PONTIAC

Service Craftsman News

No. 3 S-281

March, 1956

NEW ROCHESTER 4GC CARBURETOR ADJUSTMENT

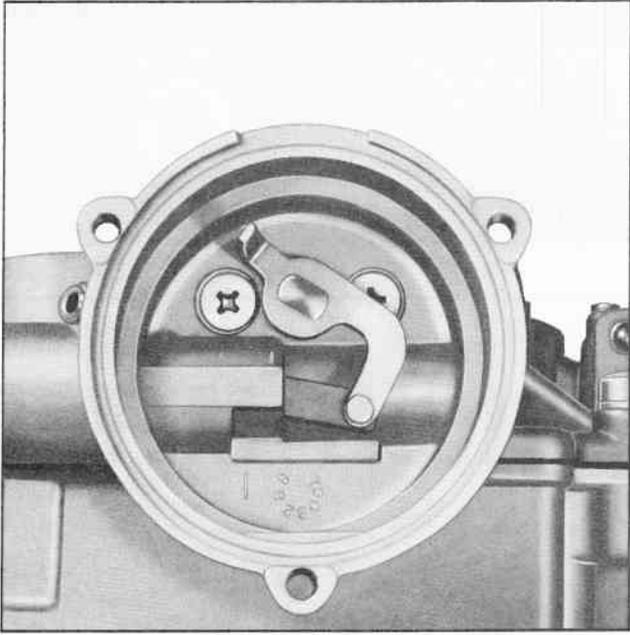
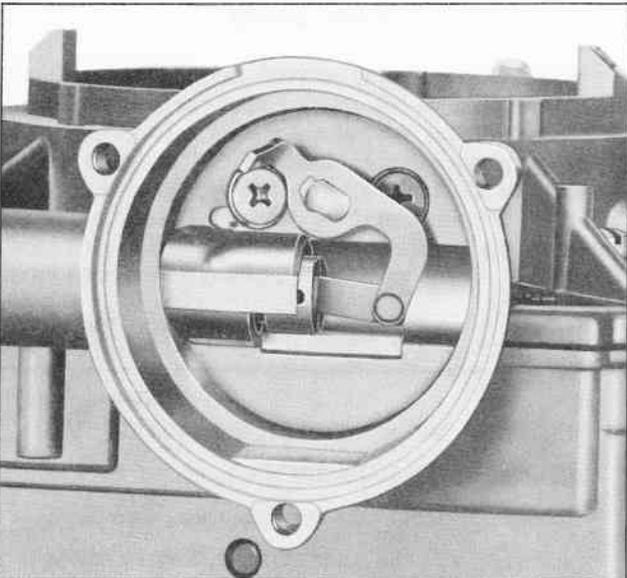
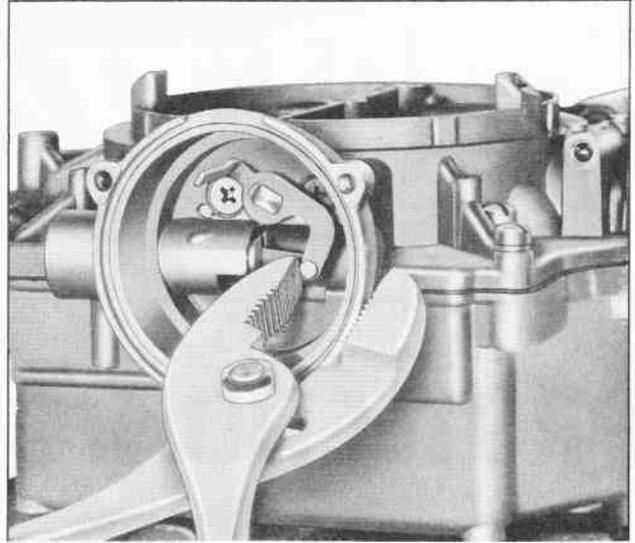
As a result of Product Information Reports covering loading during warm up of the Rochester 4GC carburetor, the contour of the choke piston link has been changed to give an increased opening of the choke valve on cold idle.

Fig. 1 illustrates the position of the choke piston with the choke valve closed before this change went into effect. Fig. 2 illustrates the choke piston after the change. Note that the piston now protrudes approximately 1/16" from the cylinder and that the piston

pin is one-half exposed. On all cases of loading the piston link should be bent using pliers as shown in Fig. 3 to achieve the new position.

The checking and setting of the choke piston as described above should be considered in the future as a regular carburetor adjustment and should be performed as such during carburetor overhauls and adjustments. Extreme care should be used to insure that no bind exists in choke system after adjustment.

CARTER 4-BARREL CARBURETOR CHANGED

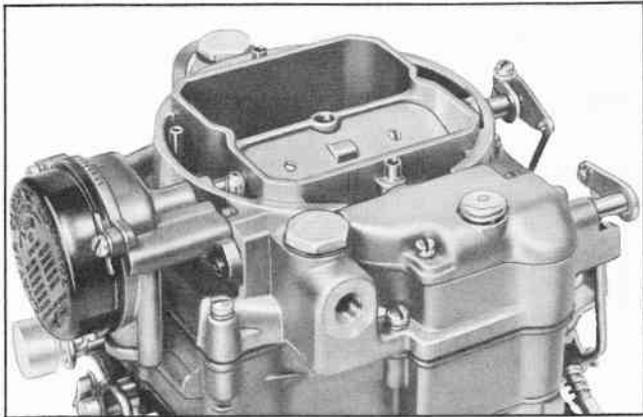
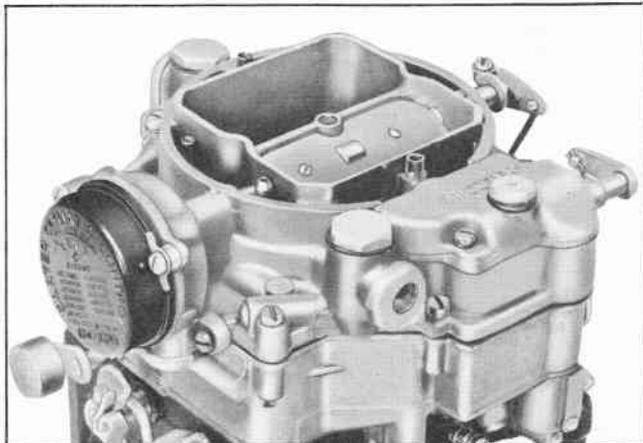
A new air horn casting and choke housing are now in production on the Carter WCFB 4-Barrel carburetor. Figs. 4 and 5 illustrate the differences in the new units. The new air horn and choke housing are not individually interchangeable with the earlier type.

Carburetors using the new parts will be known as model 2364SA and, with the exception of the first few produced (approximately 800 units built in late February and early March) will be so identified by the carburetor tag. Part numbers and other parts information will be released as soon as available.

Fig. 6 First and Second Type Throttle Body To Bowl Gasket

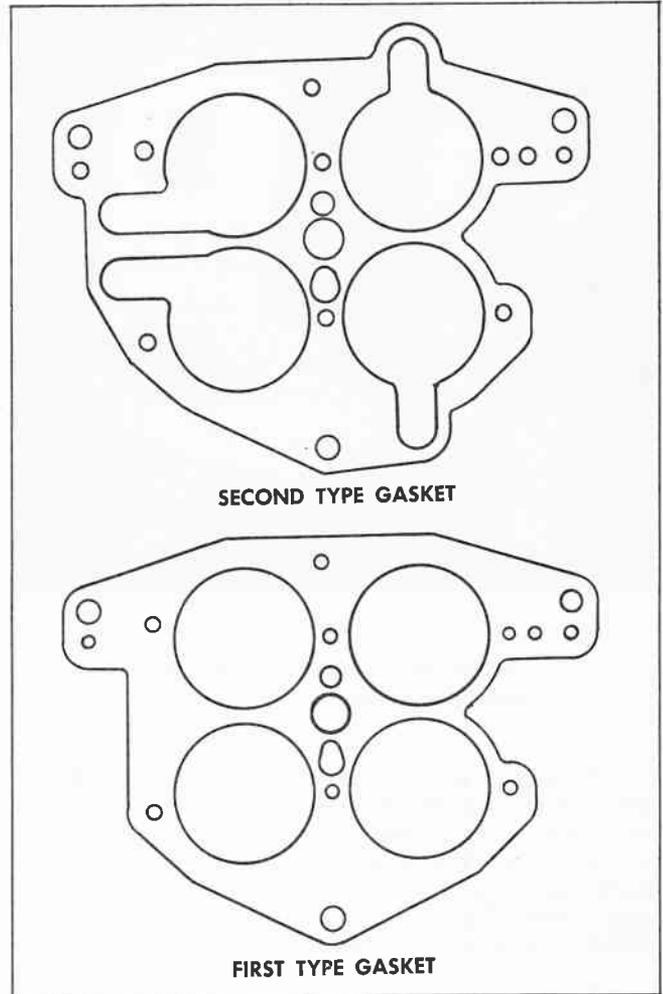
To improve hot starting characteristics of the extra horsepower engine a new throttle body to bowl gasket is now being used in production. The new gasket is released for service under part number 7009256 and should be installed on each carburetor in cases of hard hot starting. Fig. 6 illustrates the differences between the first and second type gaskets.

Fig. 7 Rochester Dual 4-Jet Carburetor

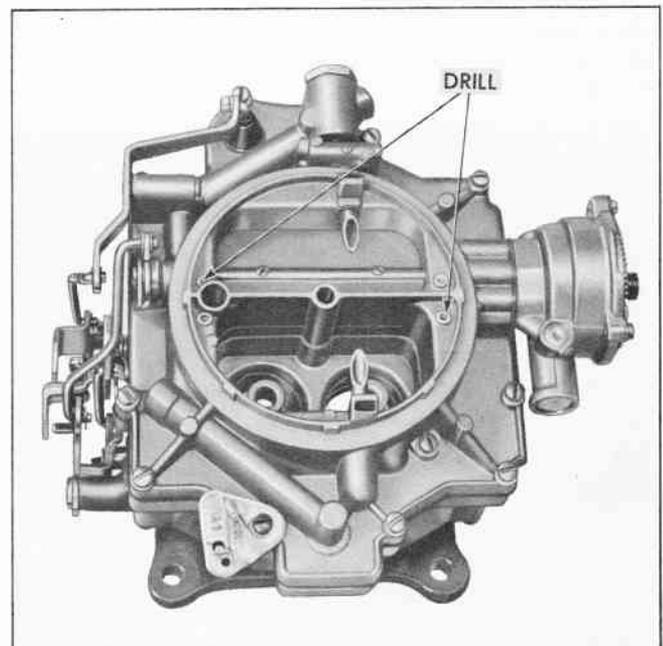
Several cases of engine stalling after a fast stop have been reported. Engineering tests have shown that this condition can be alleviated by removing the air horn assemblies from both carburetors and drilling out one internal vent in each side with a 1/8" drill. Fig. 7 illustrates the vents that should be drilled. NOTE: It is important that only the two vents pointed out in Fig. 7 be drilled otherwise excessive fuel spilling may result if car is used for racing. This condition has been corrected in production.

PUSH ROD GUIDE RELEASED FOR CYLINDER HEAD SERVICE

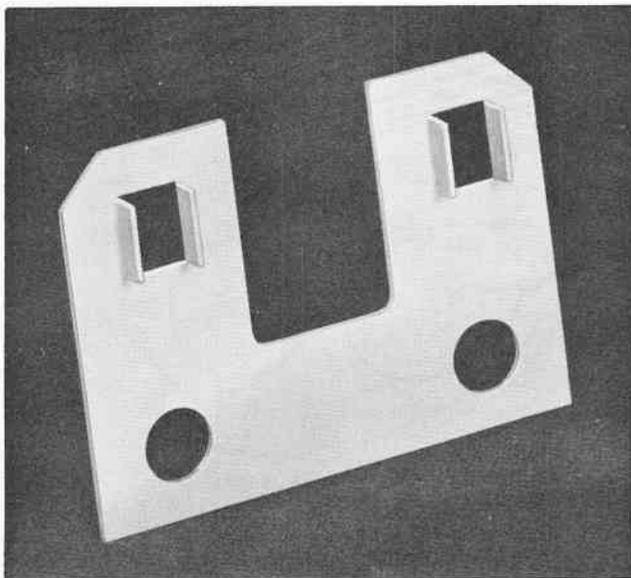
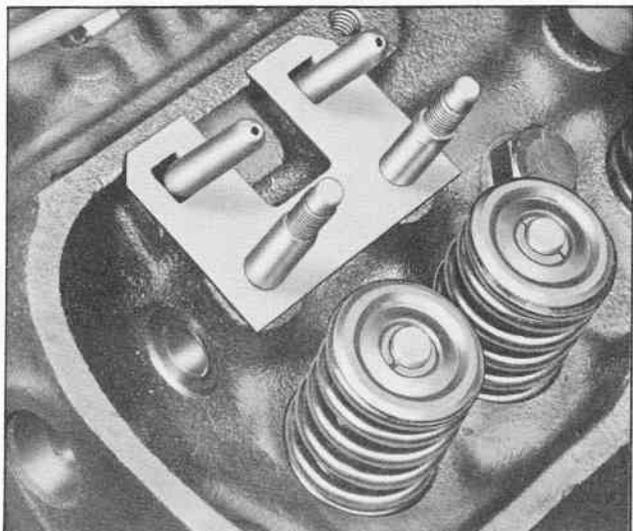
It is no longer necessary to replace a V-8 cylinder head because the guide holes for the push rods have been worn enough to cause noise or malfunction of the valve train. A new part is available to correct such cases. It is called push rod guide and is available from GMPD warehouses under part number 522937. Figure 8 illustrates the new part.

Figure 9 shows the guide in place on the cylinder head. Note that the upper edge of the guide will be held in place by the rocker arm cover. Rocker arms should be removed and replaced in accordance with shop manual instructions. Flat rate operation 6-290 should be used for establishing charges on this operation.

Fig. 12 Comparison of Front Pump and Pressure Regulator Seals

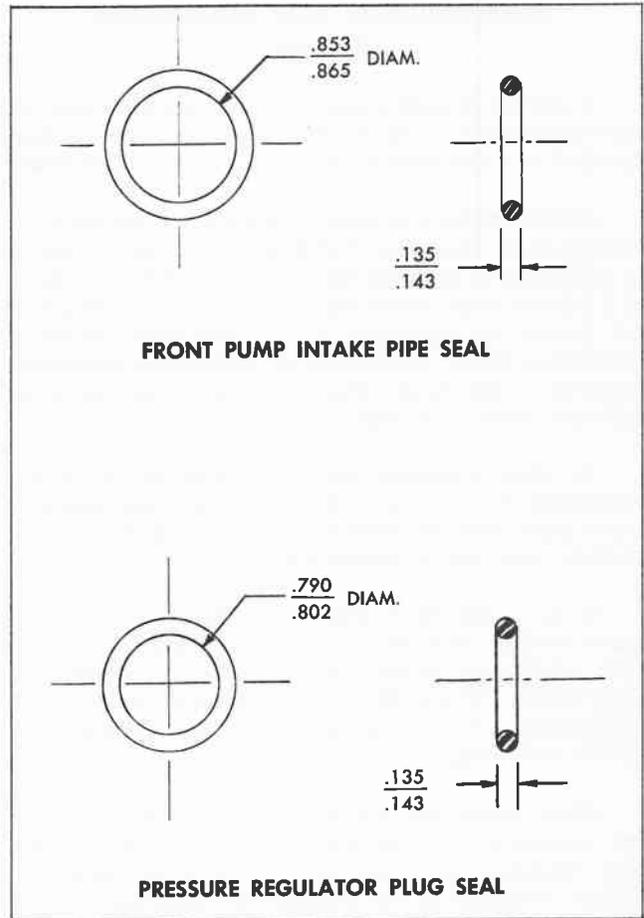
The "O" ring seal used on the front pump intake pipe is very similar to the "O" ring seal used on the pressure regulator plug. Fig. 12 shows the difference between the two seals. It will be noted that the thickness of the rubber used in both "O" rings is exactly the same; however, the diameter of the seal used on the front pump intake pipe is approximately .06" greater.

It is very important that these seals be used correctly. If the pressure regulator "O" ring seal is installed on the front pump intake pipe, a suction leak may occur causing oil starvation and foaming. Conversely, if the intake pipe seal is installed on the pressure regulator plug, an external fluid leak may result.

Fig. 13 Comparison of Old and New Type Companion Flange and Lock Plates

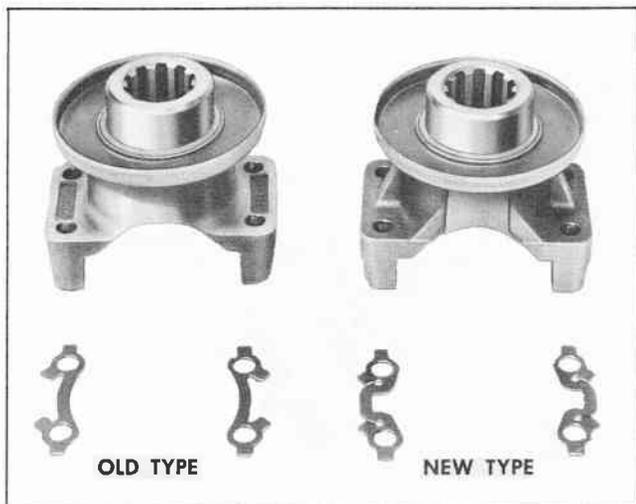
A new differential companion flange is now being used in production. The new flange is of ribbed construction and is stronger than the flange previously used. The ribbed construction of the new flange necessitates the use of a redesigned lock plate as illustrated in Fig. 13. This new lock plate is released for service under part number 5670765. The 5670765 lock plate can be used on the old type companion flange but the old type lock plate can only be used on the old type flange.
